UPDATE CHANGE NOTIFICATION # UN16490Generic Copy

TITLE: Update to the Final Notification of Transfer of Low Capacitance TVS (Transient Voltage Suppressor) Array products from ON Semiconductor COM1 Fab in Phoenix (USA) to ON Semiconductor Fab2 in Oudenaarde (Belgium).

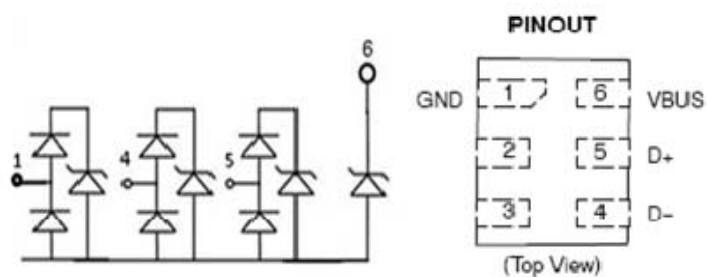
In order to facilitate certain parametric improvements during the transfer a change was made in the part schematic (shown below). This change is transparent in the performance of the part in the intended application, and the device pin out remains the same. However, the change may be noted during pin to pin ICT testing.

Pre-change Schematic

Post-change Schematic
